Sheet: /Breakouts/
File: breakouts.kicad_sch

Sheet: /Lasors/ File: lasor.kicad_sch		
Title:		
Size: A4	Date:	Rev:
KiCad E.D.A. 8.99.0-2629-g91569cf3cf		Id: 8/10

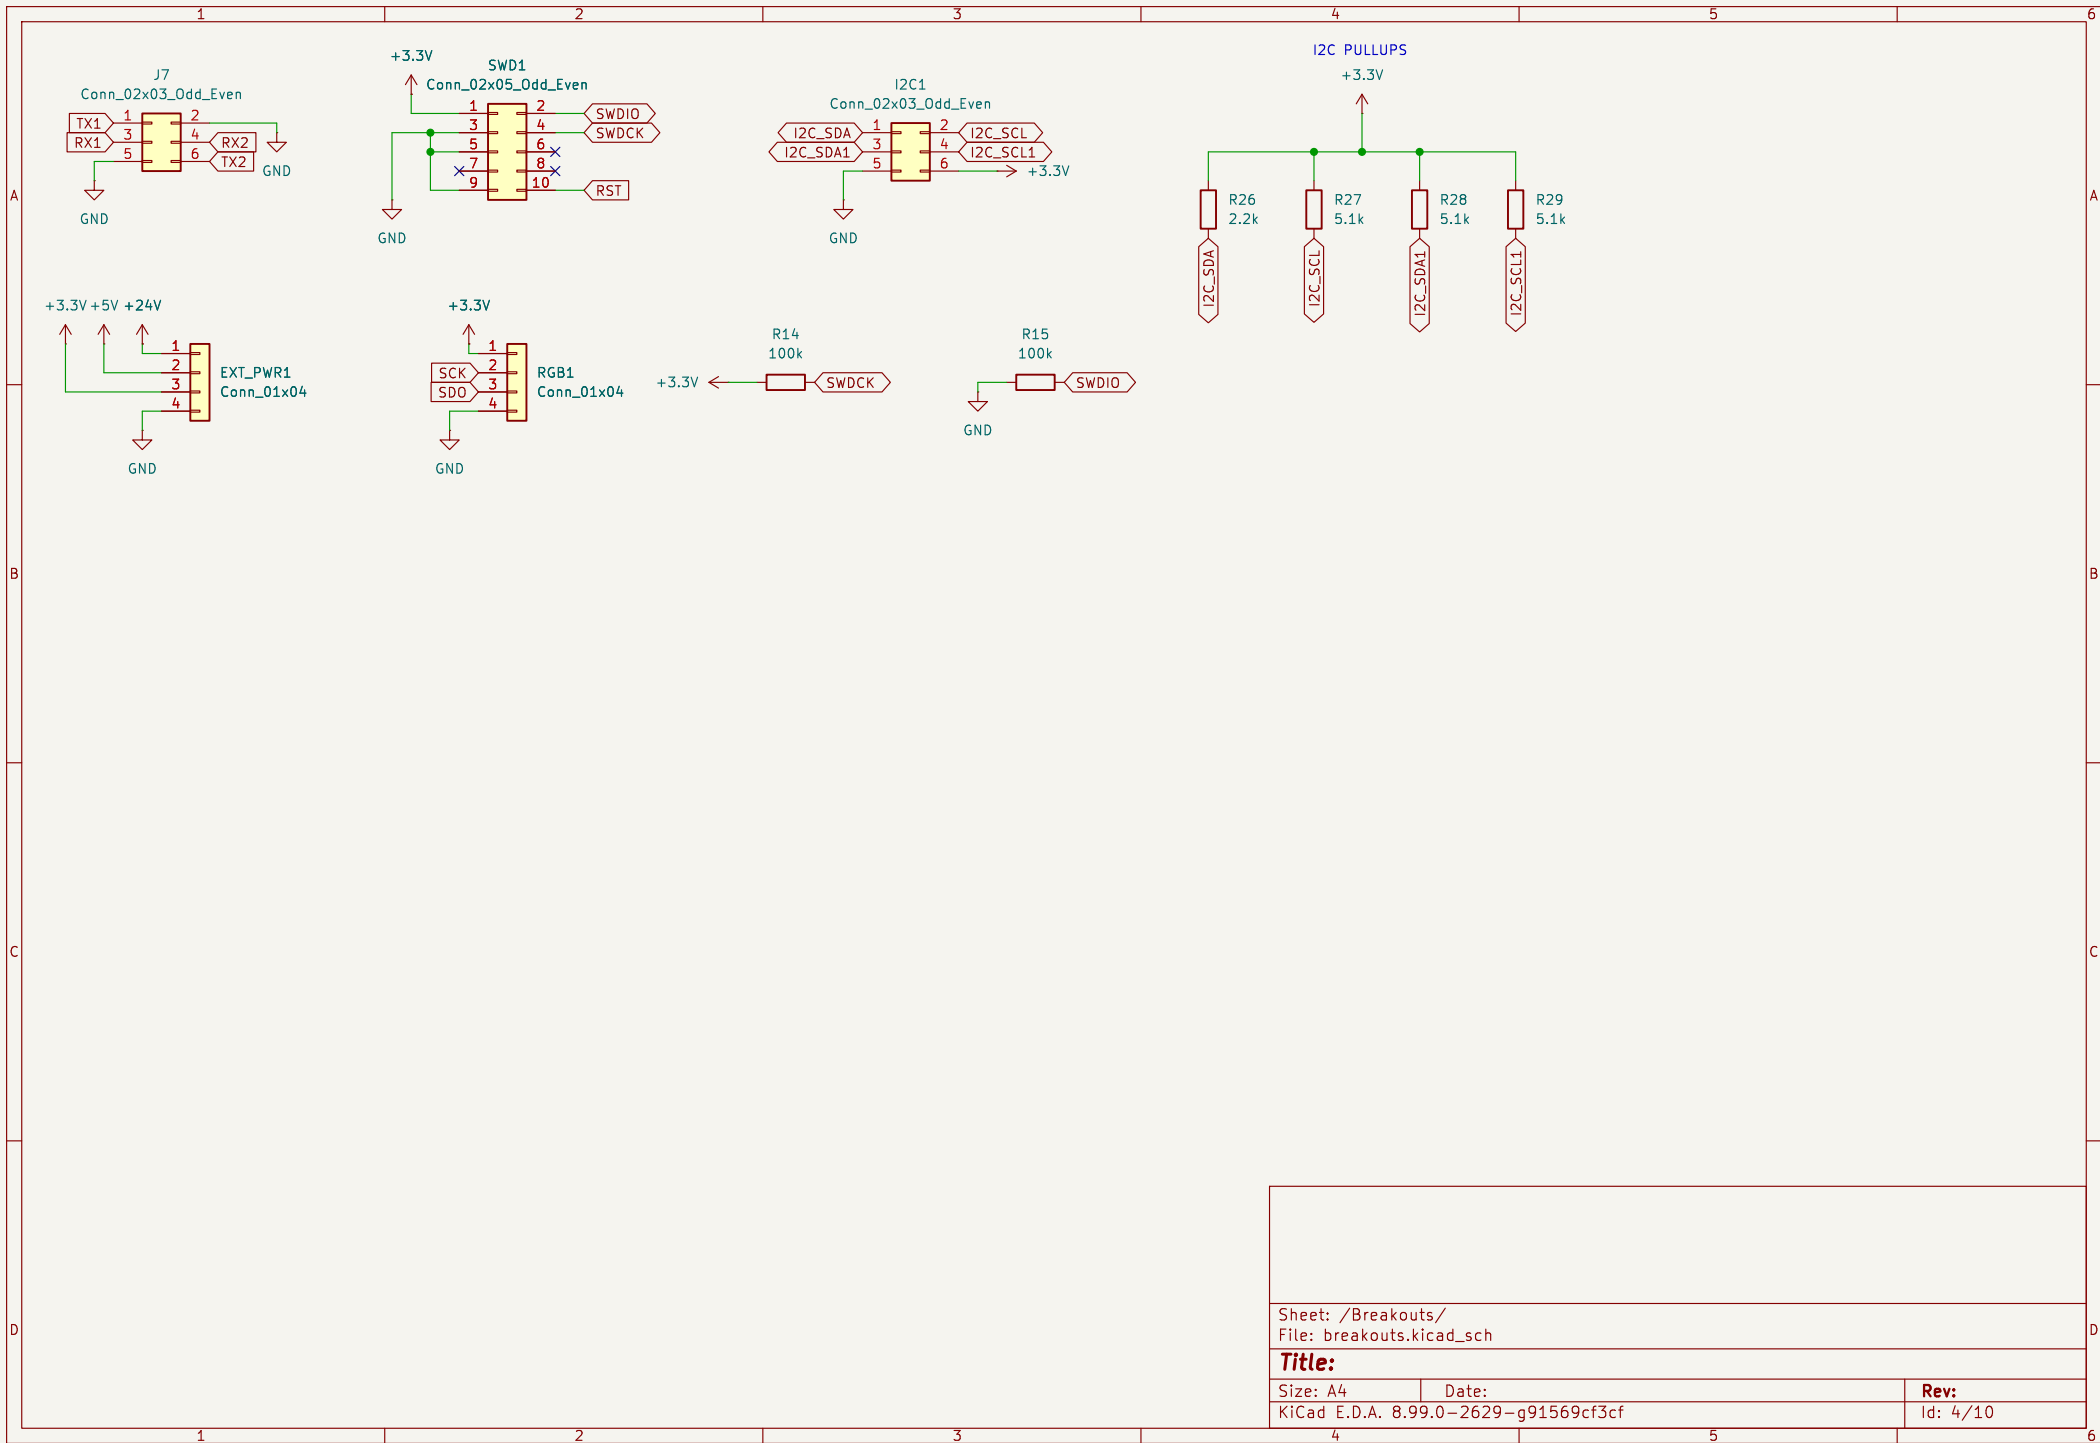
DON'T NEED ANYMORE

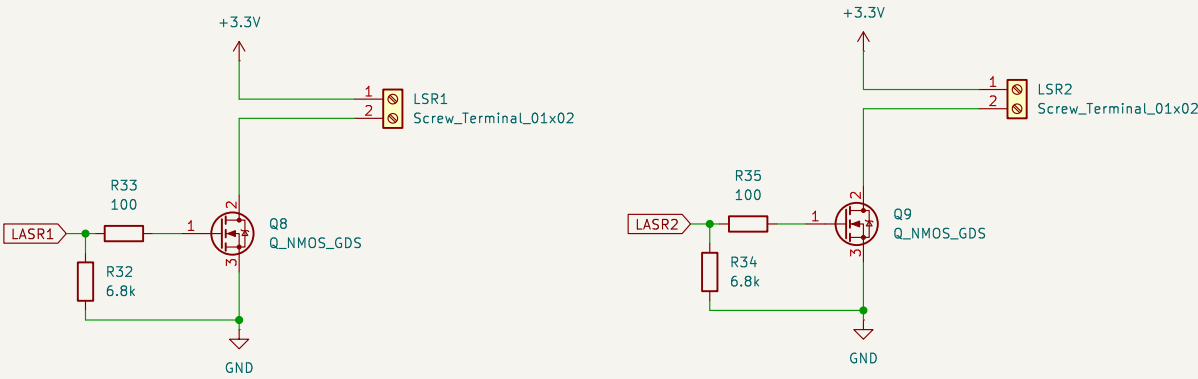
Lasers:
DONE????

also the laser should be operable via gpio, probably needs a small mosfet or something for it
also undervolting the laser was discussed, may require a lower voltage ldo for that
